ADDENDUM NO. 2

March 1, 2022

**TIMOTHY BALL ELEMENTARY SCHOOL ADDITIONS, RENOVATIONS,
AND RELATED WORK
Crown Point, IN 46307**

This Addendum forms a part of and modifies the Bidding Requirements, Contract Forms, Contract Conditions, the Specifications, and the Drawings dated February 7, 2022 by Gibraltar Design. Acknowledge receipt of the Addendum in the space provided on the Bid Form. Failure to do so may subject the Bidder to disqualification.

DRAWING
**UNIT "B" MECHANICAL
ENLARGED DEMOLITION
PIPING PLAN**

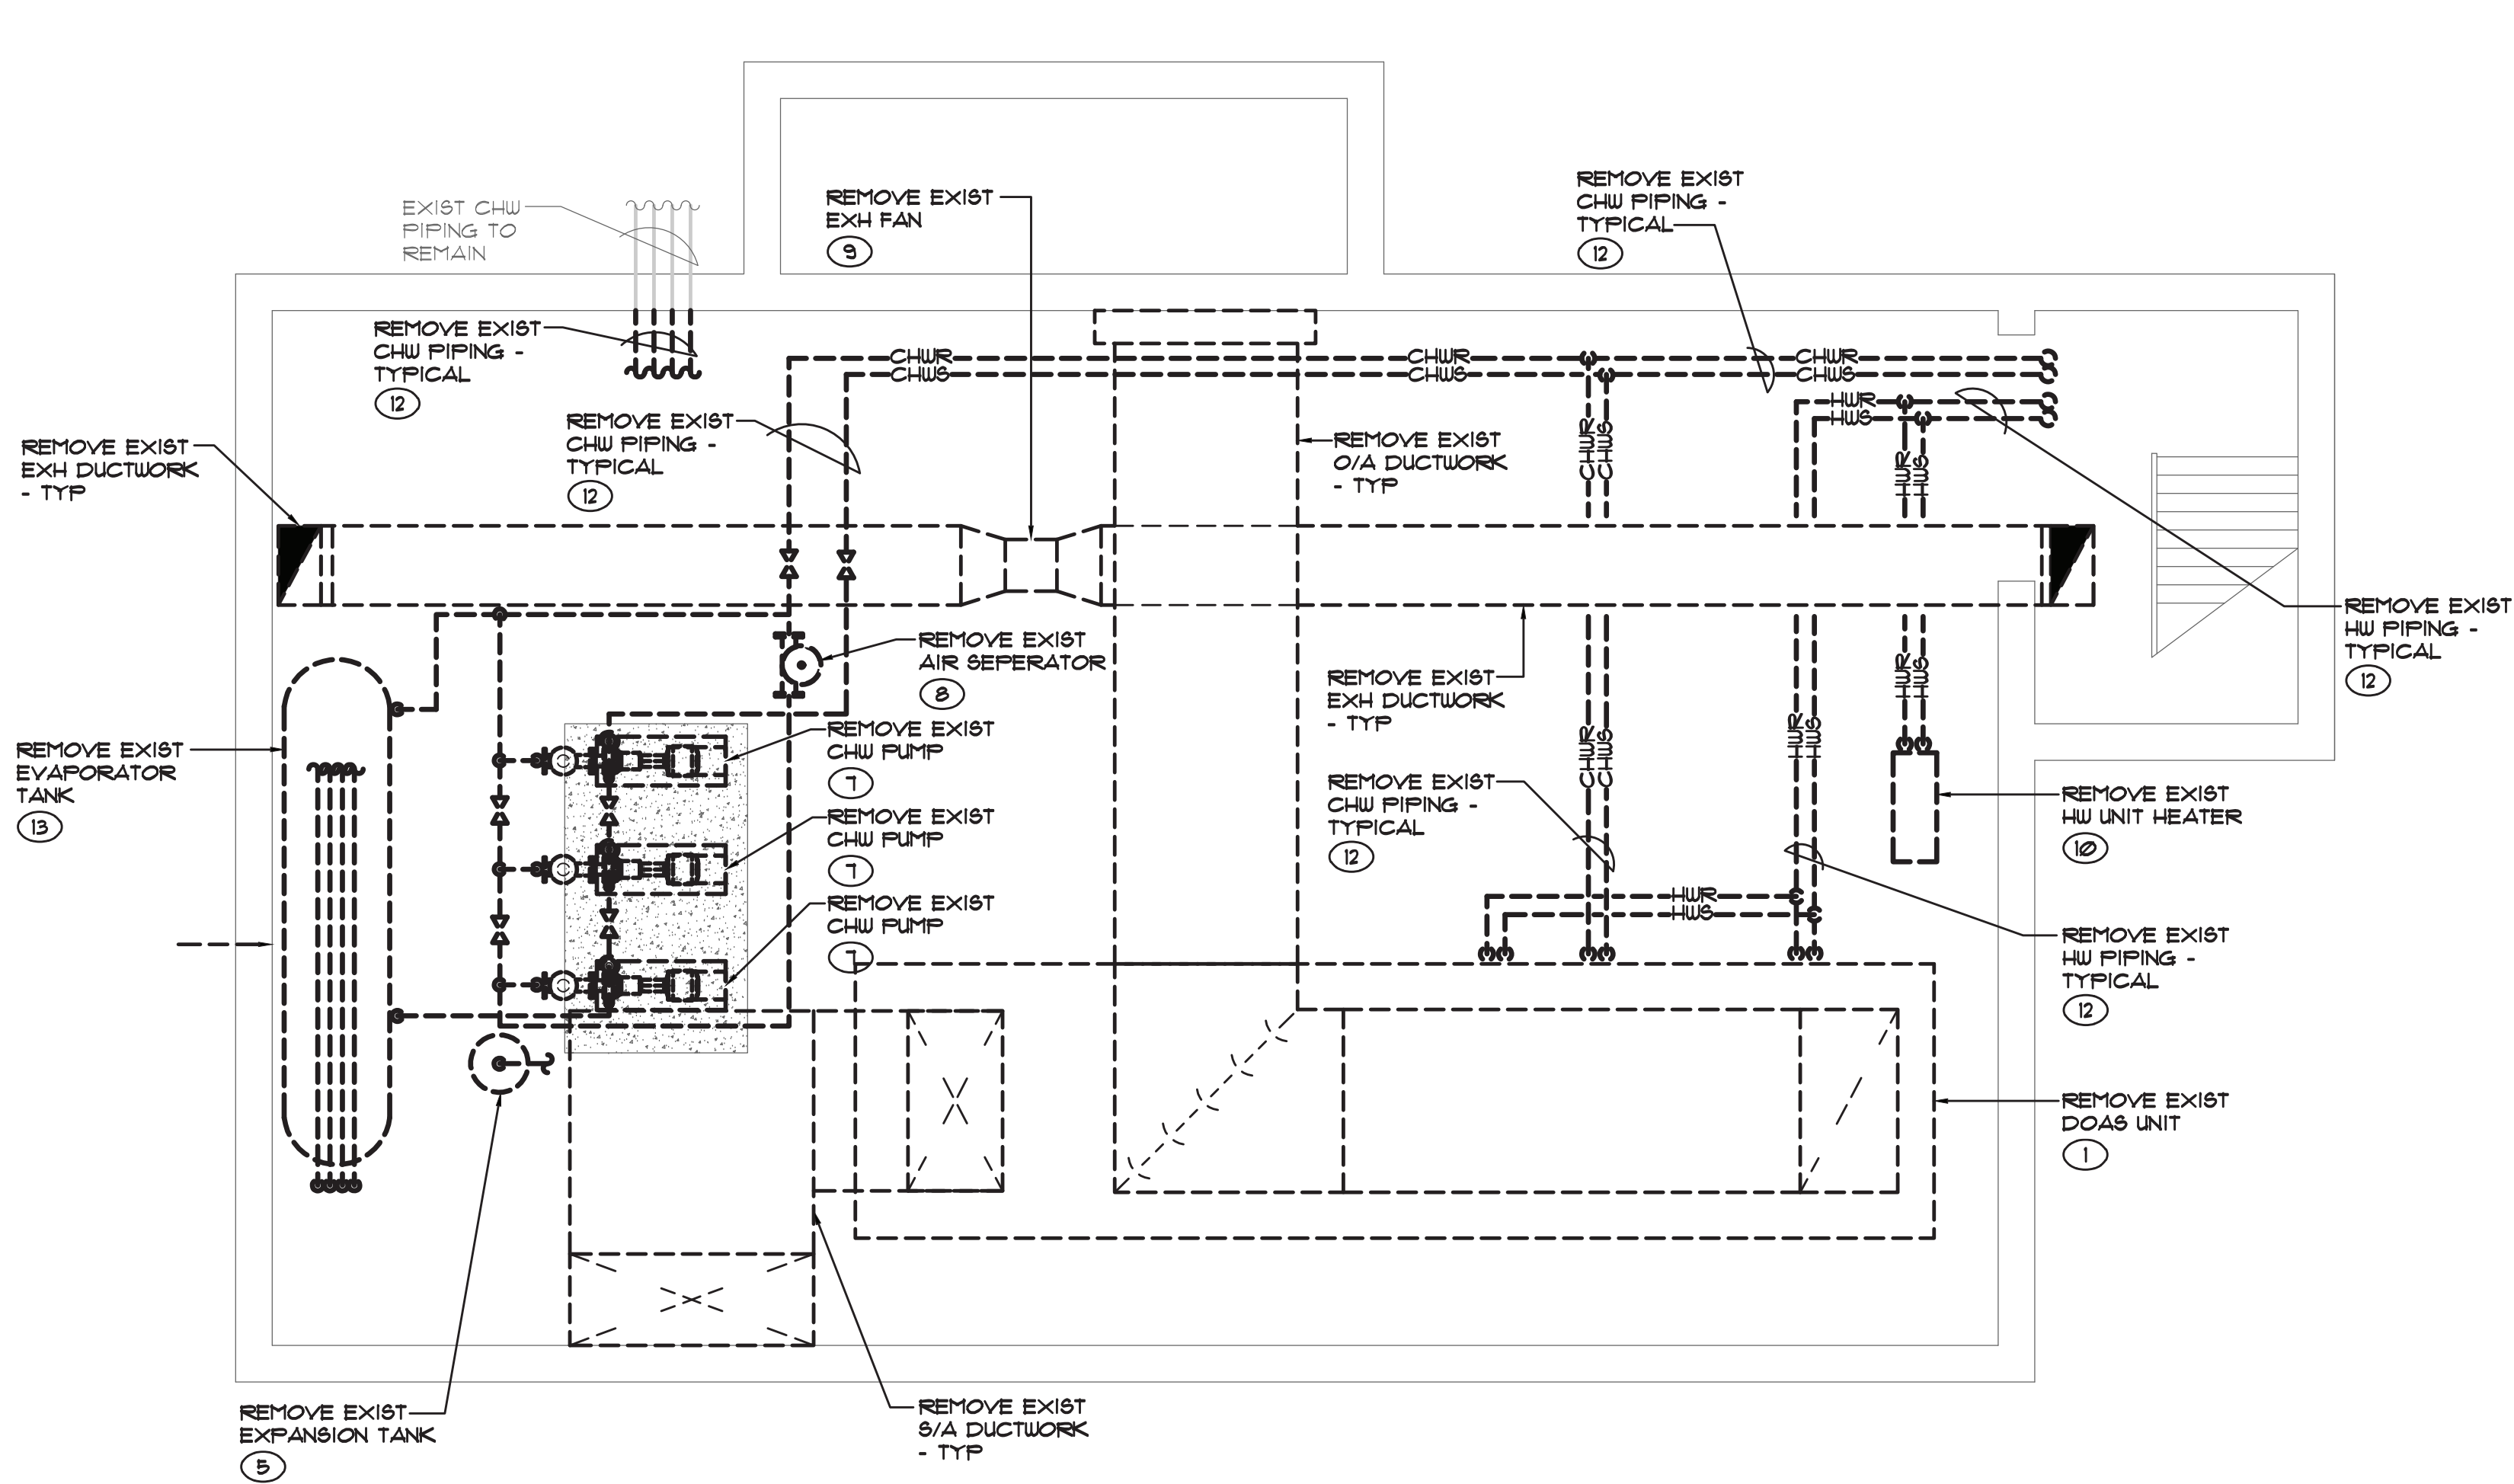
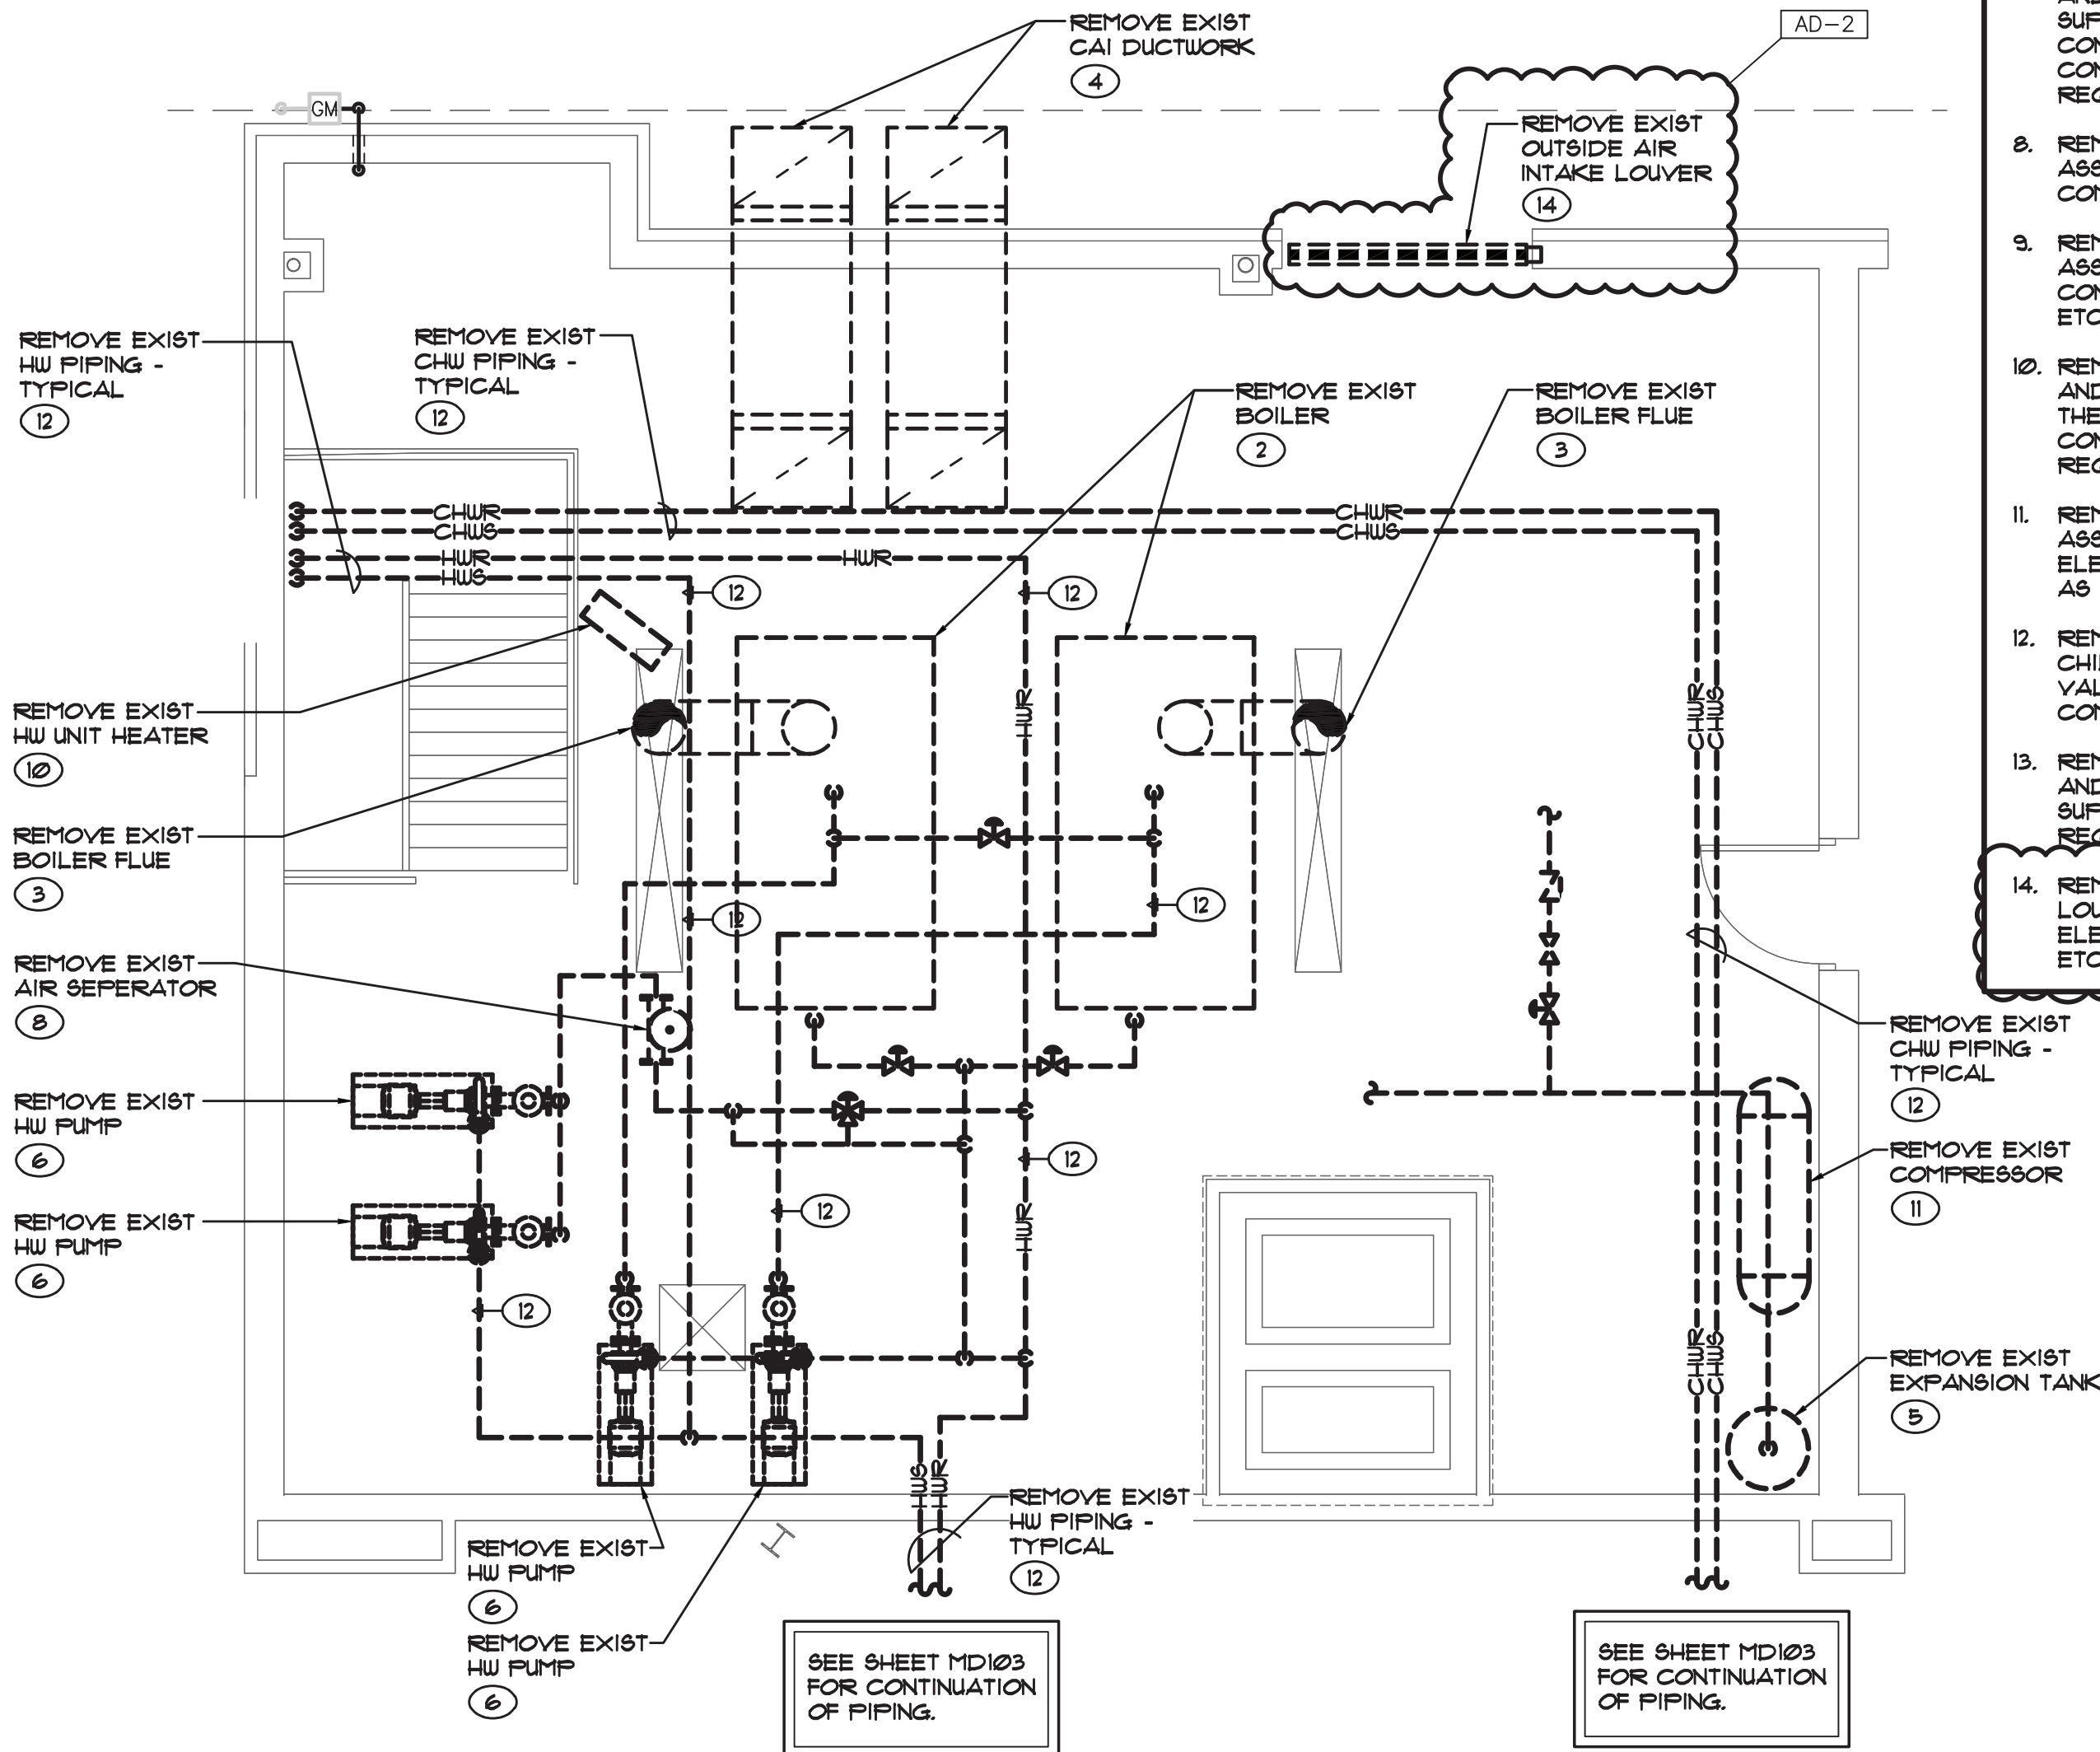
23. Sheet MD104

- A. Refer to revised, full size drawing, included in this Addendum, for the following revisions:
1. Added Demo Louver.
 2. Added Sheet Note 14.

GIBRALTAR DESIGN SHEET
A MV101

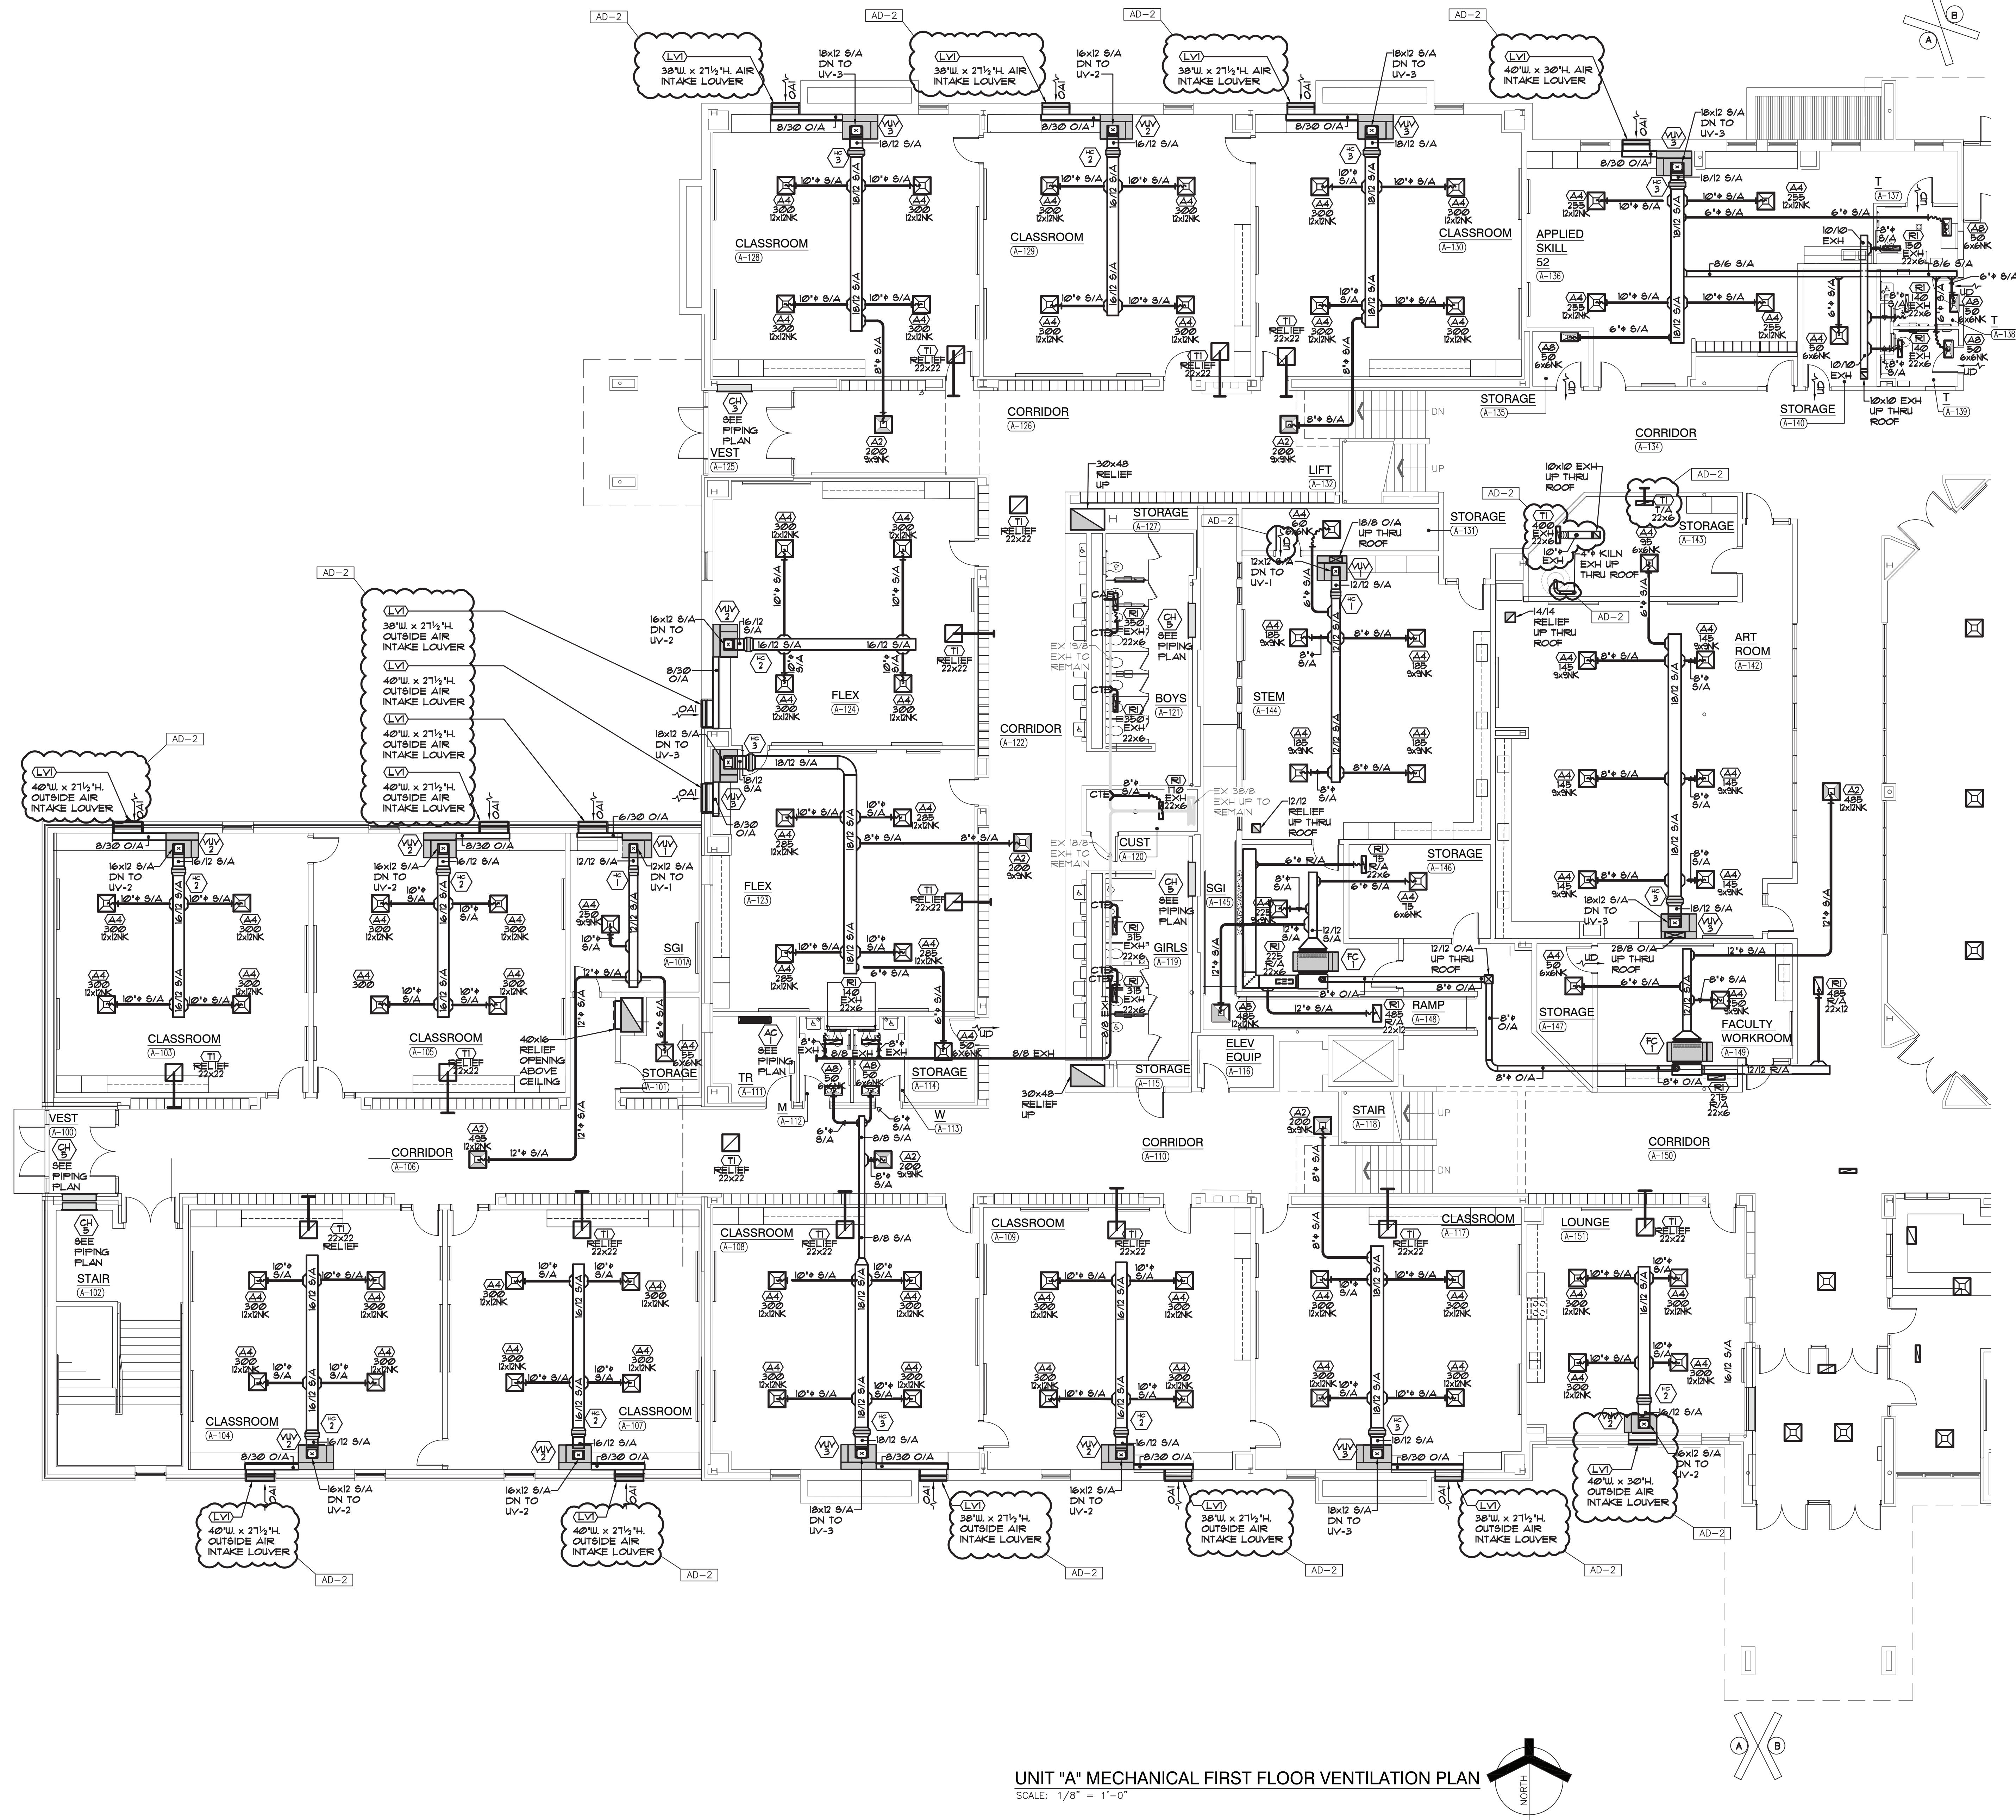
24. Sheet MV101

- A. Refer to revised, full size drawing, included in this Addendum, for the following revisions:
1. Revised louver size to 40"w x 27 ½"h in Classroom A-103, A-104, A-105, A-107, SGI A-101A and Flex A-123.
 2. Revised louver size to 38"w x 27 ½ "h in Classroom A-108, A-109, A-117, a-128, A-129 A-130, and Flex A-124.
 3. Revised louver size to 40"w x 30"h in Applied Skill 52 A-136.
 4. Removed ducted outside air to roof for VUV-2 and added 40"w x 30"h louver to Lounge A-151.
 5. Added undercut door to Storage A-131.
 6. Added exhaust grille to Storage A-143.
 7. Revised location of kiln exhaust and general exhaust through roof in Storage A-143.
 8. Added transfer air into Storage A-143.
